Appendix G
Comments Received on the Draft EA and USCG Responses

Re: Draft Environmental Assessment
Hurricane Sandy Proposed Recapitalization Project
Rebuild USCG Station Sandy Hook, New Jersey

USCG Response to EA Comments Received
USCG Station Sandy Hook Hurricane SANDY Recapitalization Project

STANDARD 9:

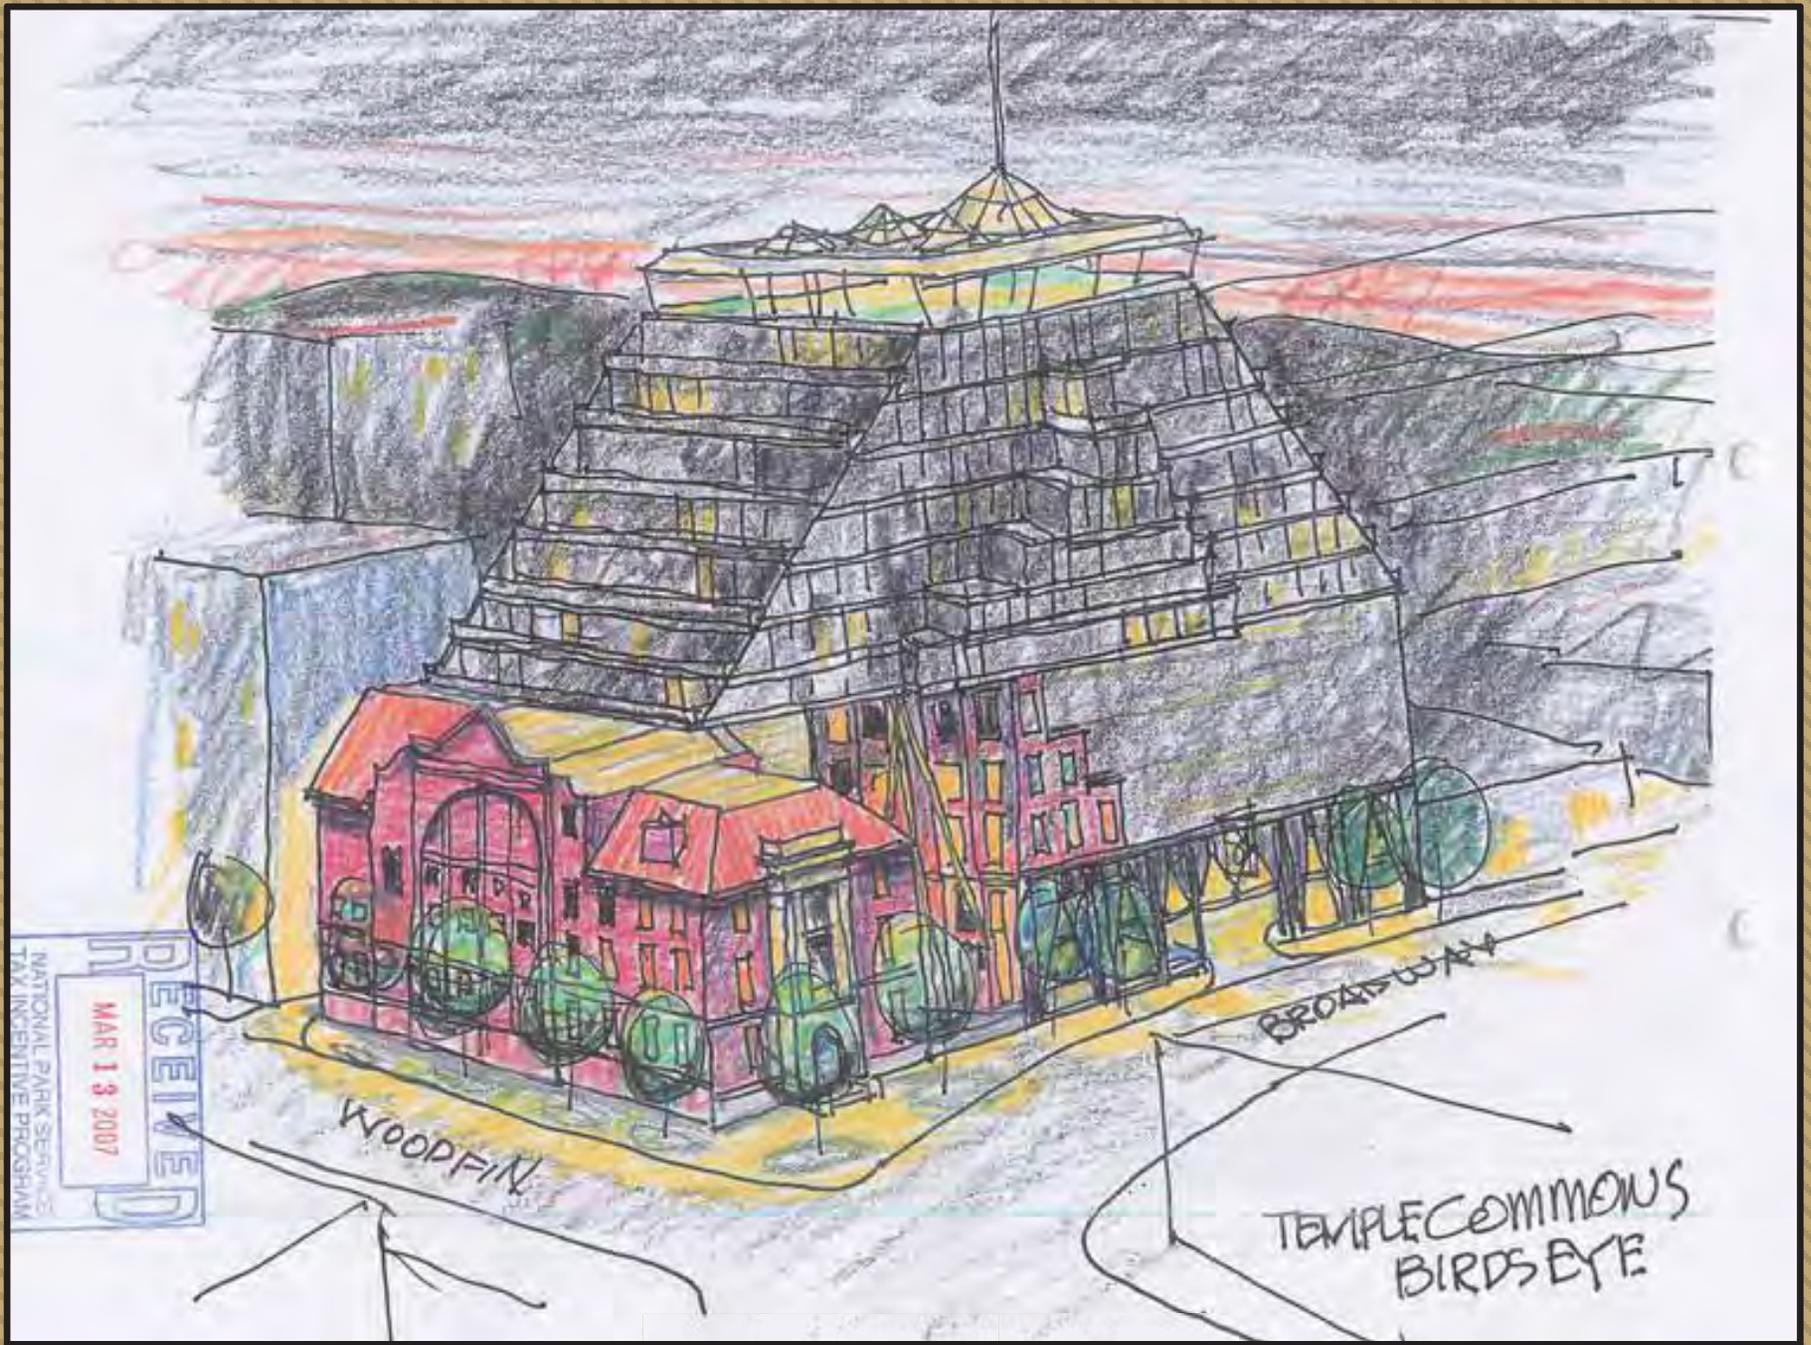
New additions, exterior alterations, or related new construction shall not destroy historic materials that characterize a property. The new work shall be differentiated from the old and shall be compatible with the massing, size, scale, and architectural features to protect the historic integrity of the property and its environment.

Egads!

Incompatible Additions

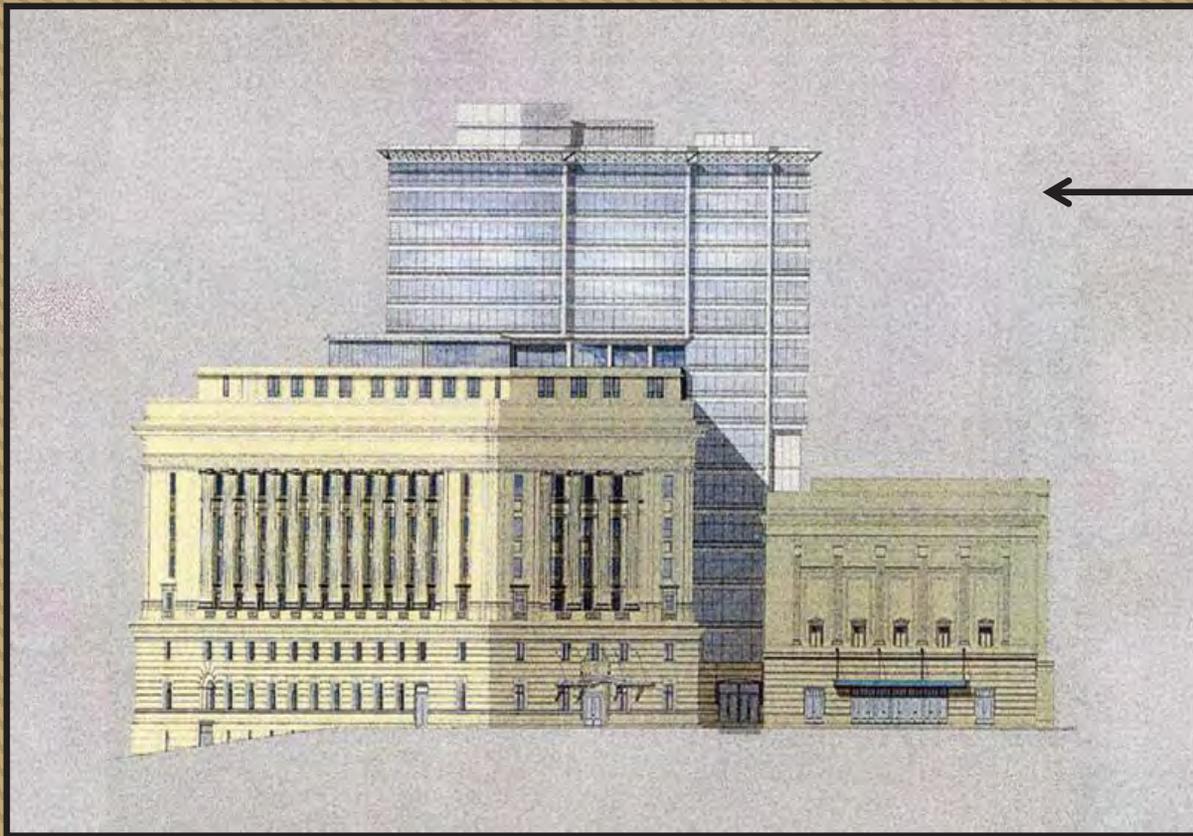
**Proposed tower
does not meet the
Standards**
